Technical Bulletin

**Subject: Replacement Coil Connector with Slip Ring
(Spiral Spring), Removing Additional Wiring**

Number: 01-01

Model(s): TT

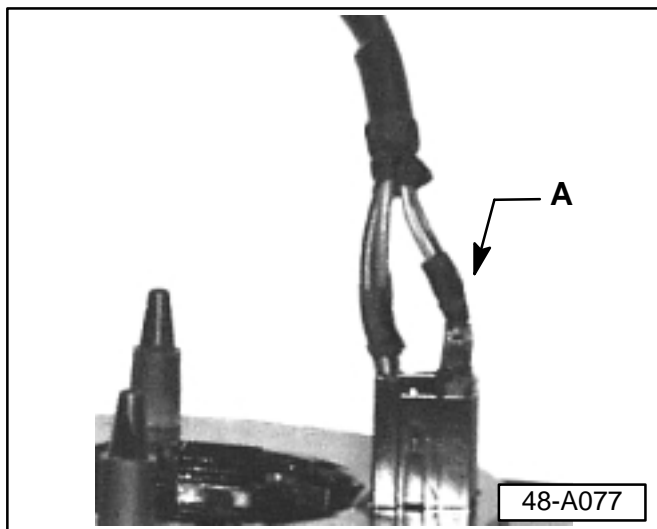
- ◀ Spiral spring, Part No: 1J0 959 654Q currently supplied as a replacement part includes a connector and wiring -A- which is used for heated steering wheel applications.

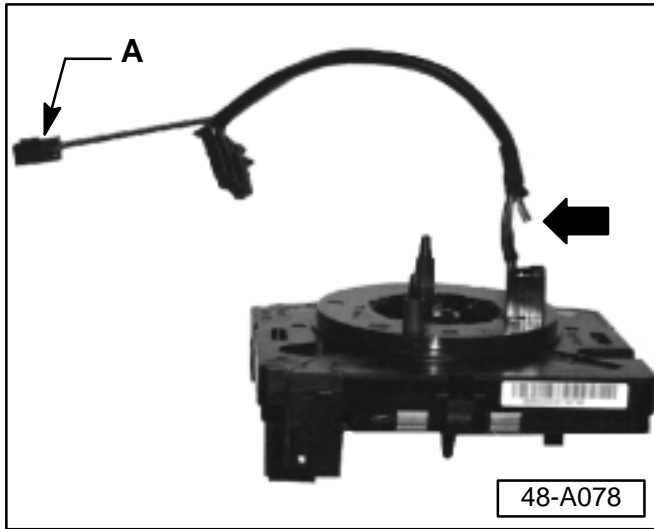
- ◀ – Disconnect connector -A- for Brown 0.3mm and Black 0.3mm wires from spiral spring.

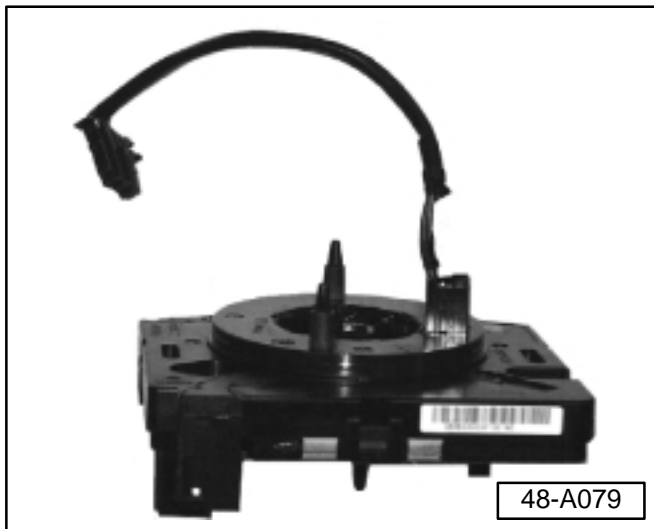
- ◀ – Cut wires above removed connector (arrow).
- Pull connector -A- and wires from protective sleeve and discard.
